NUMBER: 23-023-17

Urea Supply Line - Buzz, Squeaks and Rattles (BSR)

This bulletin involves installing a foam pad to the shield/deflector to stop urea line BSR.

2014 - 2016 (WK) Jeep Grand Cherokee

Fig. 1 Location of Shield

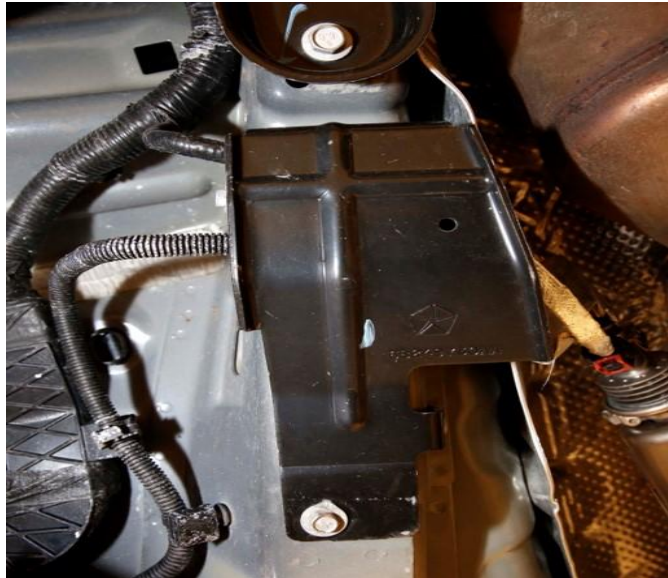
1. Lift and support the vehicle.
2. Locate the shield/deflector under the right front of vehicle ([Fig. 1](#)).

Fig. 3 Shield After Foam Pad Applied

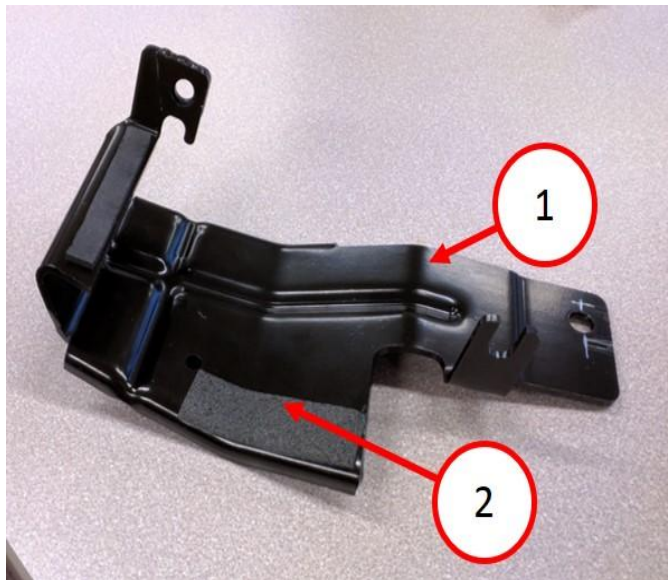
4. Apply the foam pad as shown in (Fig. 3).

- 1 - Shield/Deflector (Removed from vehicle)
- 2 - Area Where Foam Pad Should Be Installed

NOTE: Make sure the drain hole is not covered by the pad.
